NOTE  
 Numbering relates to descriptions of proposed changes within written statement accompanying application.

PROJECT	Extension, Alterations and Refurbishment		
CLIENT	Mr and Mrs S Wilson		
ADDRESS	The White House, Askham Richard, York, YO23 3PT		
DRAWING NAME	Stage 3 - Planning - Proposals		
SCALE(S)	DATE DRAWING CREATED	DRAWN	
1:100/1:10	23/01/2024	mp	
JOB NO.	DRAWING NO.	REVISION	
23024	PL01	C

South West Elevation

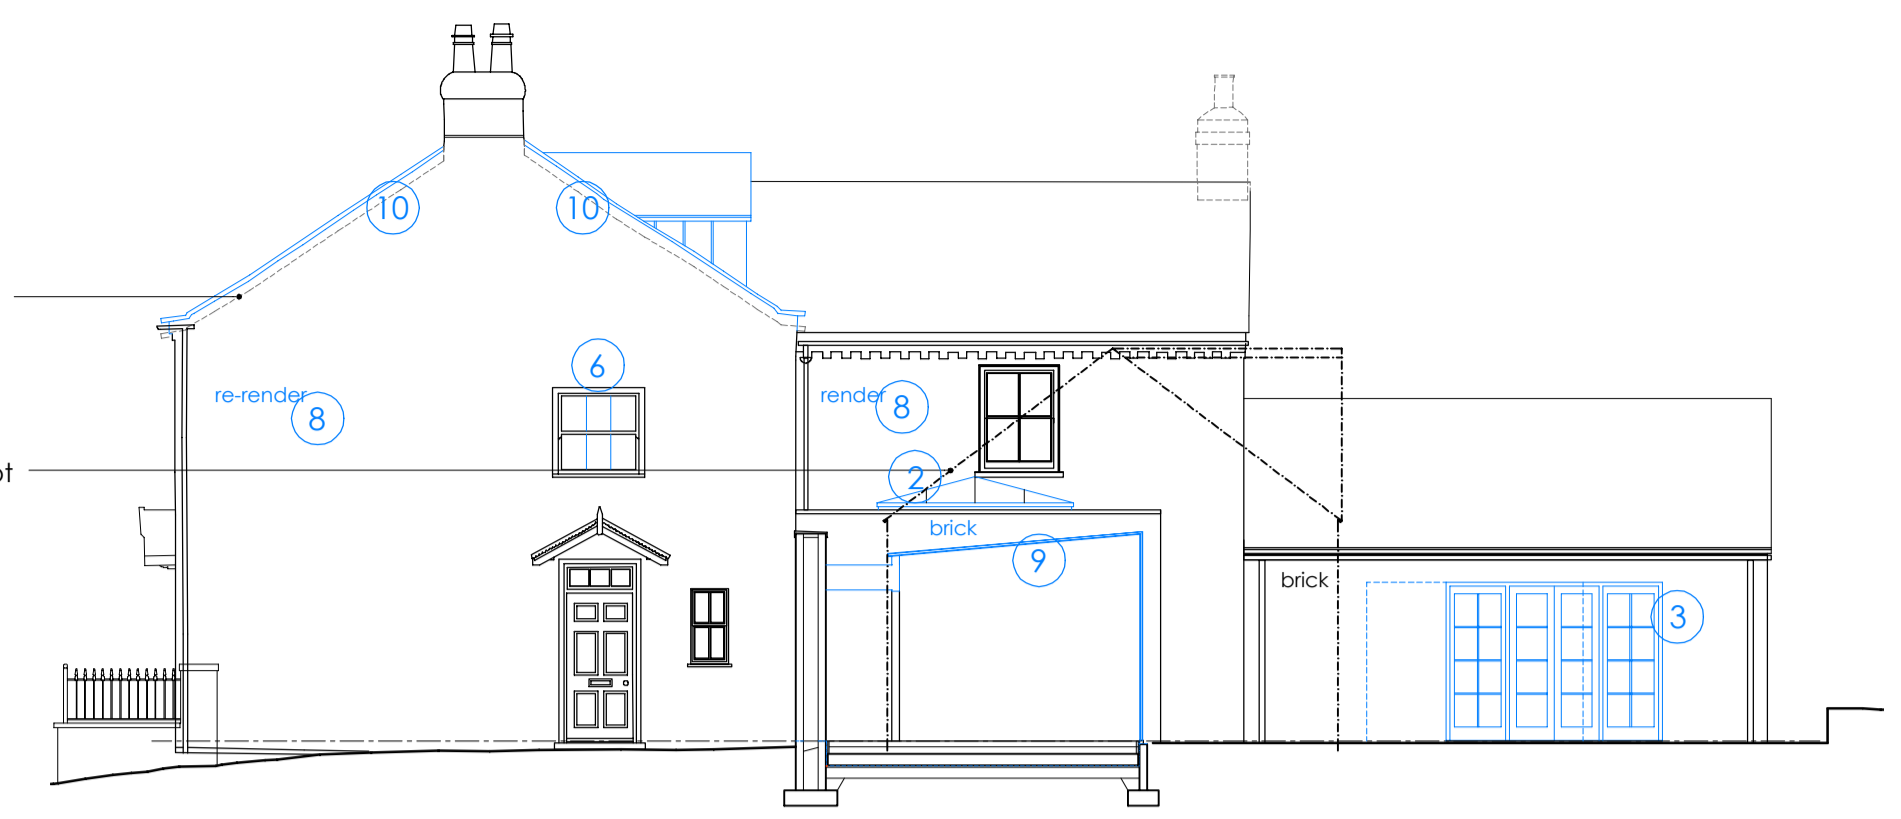
Ridge line as existing shown in black dashed line.  
 Parapet verge line as existing shown in black dashed line.  
 Eaves line as existing shown in black dashed line.  
 Outline of garage in foreground, shown in dot and dashed line.

Roof Plan

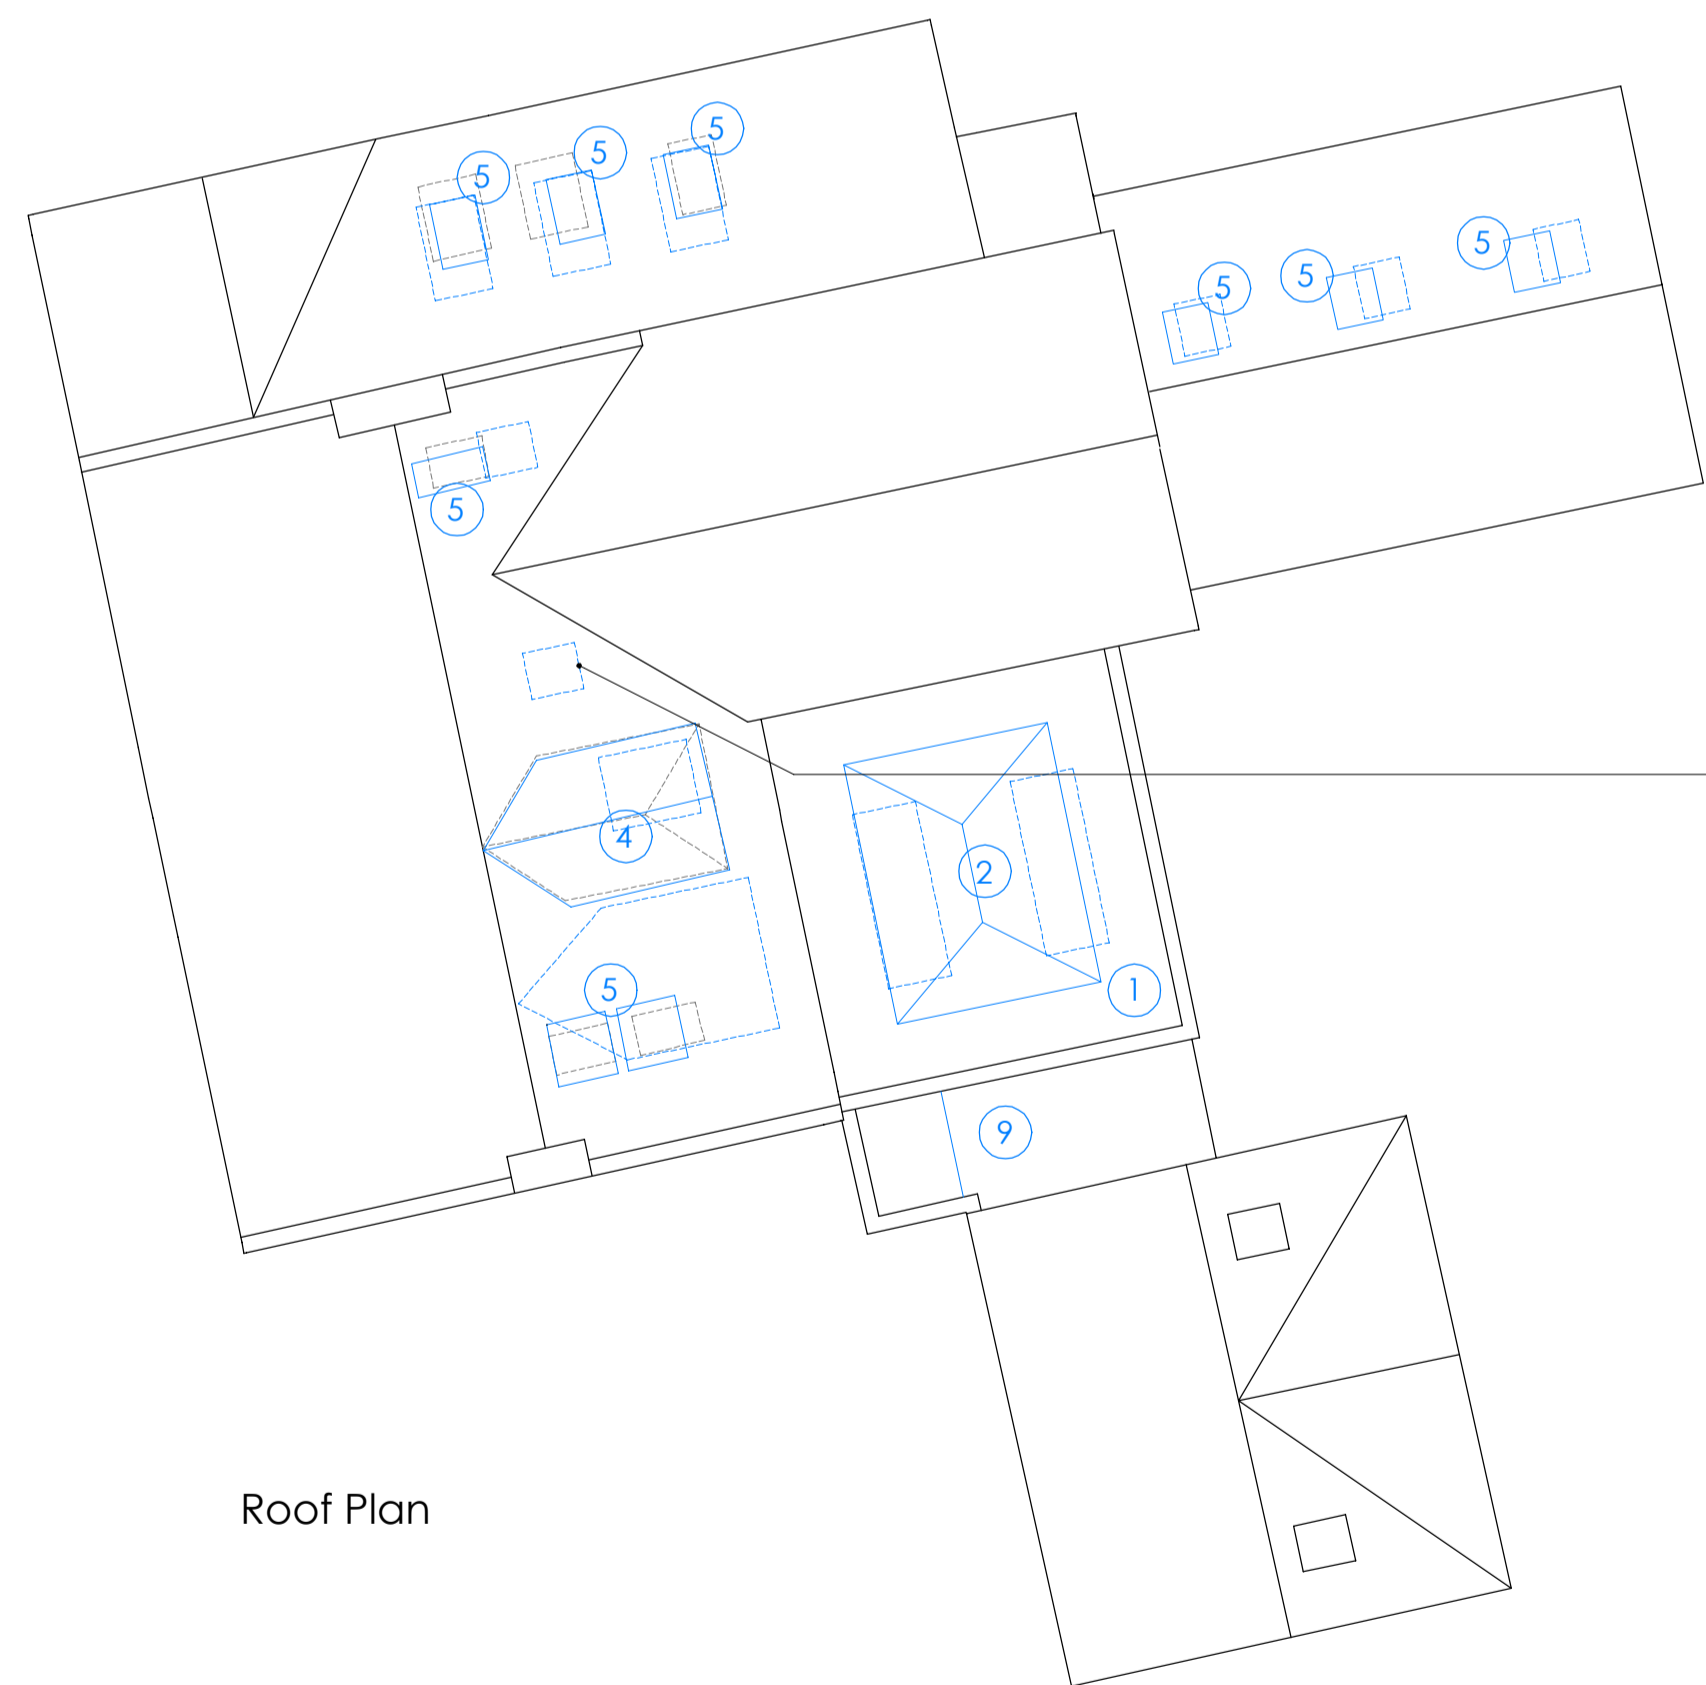
Minimal raise in height of roof, applies at ridge, eaves and verges.  
 Half round clay ridge tiles to match existing.  
 Clay pantiles to match existing.

Level of existing pantiles and ridge tiles shown in green dashed line.  
 Proposed roof insulation, over rafter, insulation to be PIR to ensure the roof build up is the thinnest possible and reduce roof level increase to minimum.

New rooflight previously approved to be omitted entirely.
